# California Native Plant Society

May 20, 2019

RE: SEIR for Otay Ranch Village 13 Master Planned Community-Resort Village: PDS2004-3800-04-003; PDS2004-3810-04-002; PDS2004-3600-04-009; PDS2004-3100-5361A & B; LOG NO. PDS2004-04-19005; SCH NO. 2004101058

Figure 1. All Nuttall's scrub oak samples recorded in the San Diego Plant Atlas.

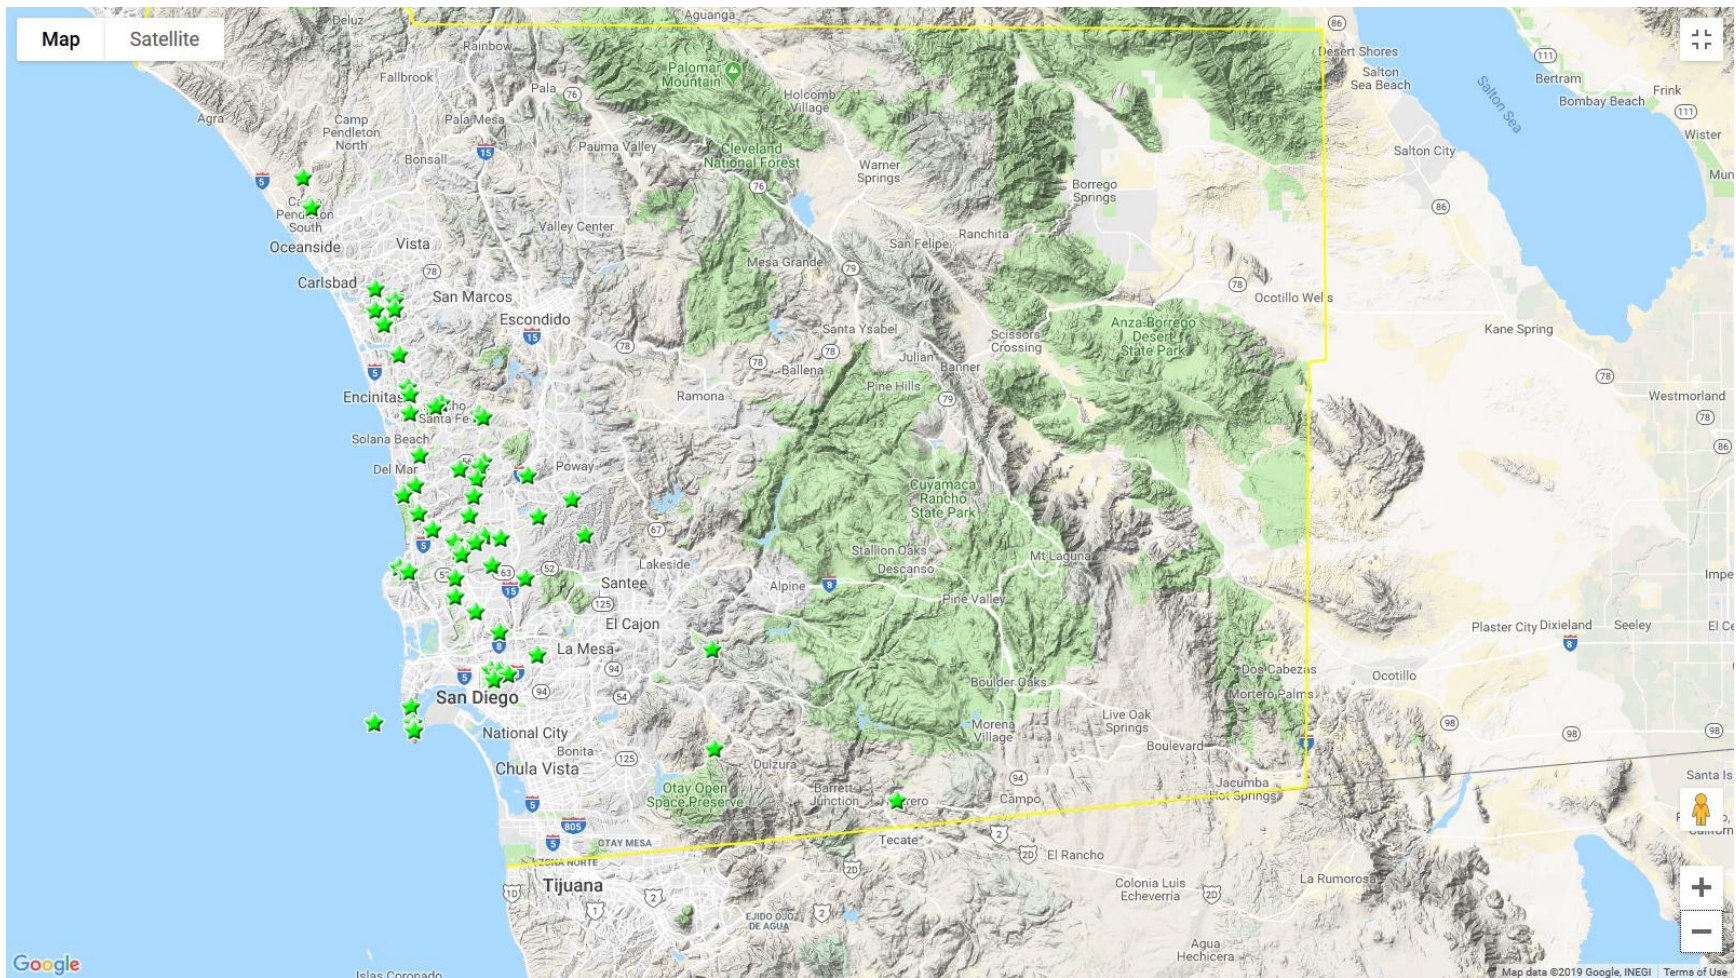
This identification of the oaks based on the literature is almost certainly in error. The literature on Nuttall's scrub oak has issues, and the idea that it grows "almost always within sight of the ocean" can be readily disproved, as demonstrated in figures 1 and 2 (next two pages page). Figure 1 shows the Nuttall's scrub oak samples in the San Diego Natural History Museum (SDNHM) Plant Atlas<sup>2</sup>, while Figure 2 is a blowup of Figure 1, showing the area around the Project site. **The important thing to note is that the herbarium head, Dr. Jon Rebman, has verified the identity of the oaks in the SDNHM collection, so their record constitutes an accurate range map.**

Figure 2. The locations of three Nuttall's scrub oak specimens near the Project site, in the Olay Open Space Preserve lower center, just east of the Project), west of Potrero (lower right) and south of Dehesa and Sycuan Casino (upper center).

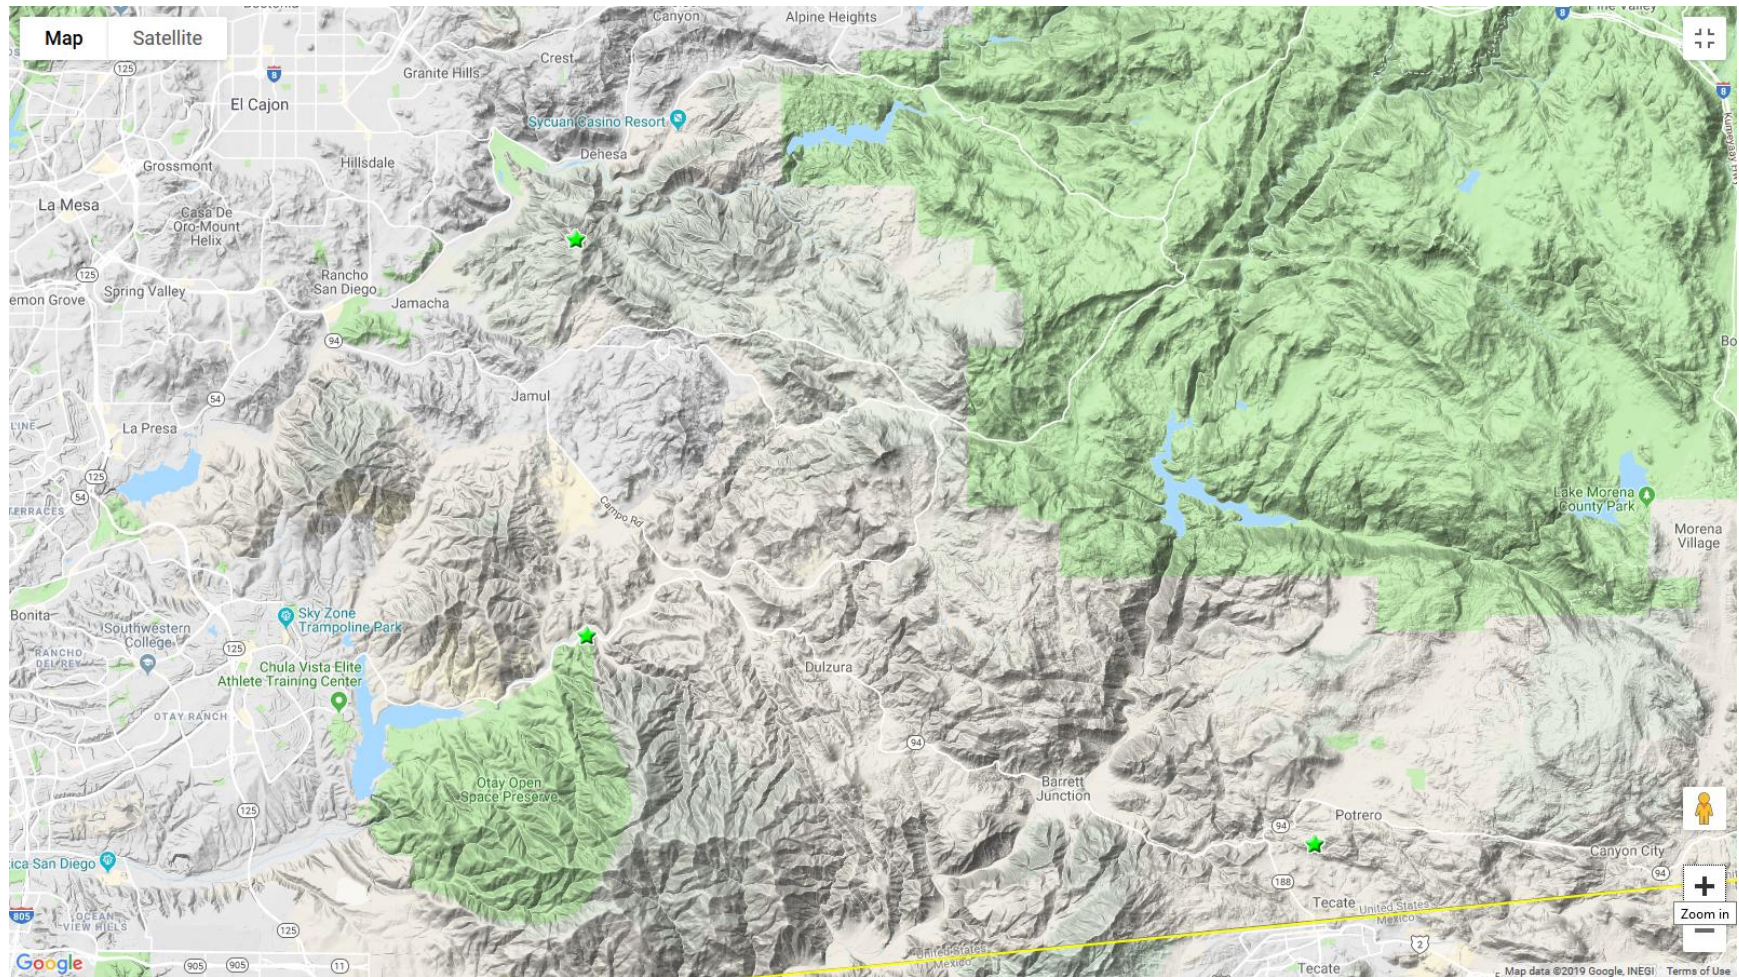
Moreover, I verified that two specimens of Nuttall's scrub oak collected east of the site (specimens 79441 and 180320) were, when I examined the specimens at SDNHM, definitely Nuttall's scrub oak. It is a species I am quite familiar with, as I have a PhD in botany, and I see it every week on Del Mar Mesa. That identification was confirmed (as noted on each specimen sheet) for 180320 by Dr. Jon Rebman, head of the herbarium and a leading expert on San Diego's flora, and for 79441 by Dr. Kevin Nixon, the oak expert who created the modern name of *Quercus dumosa*.

Because of the herbarium specimens, we can confidently state that the Project site is within the physically documented range of Nuttall's scrub oak, as the Project site is west of the easternmost documented and confirmed locations for this species in southern San Diego County.
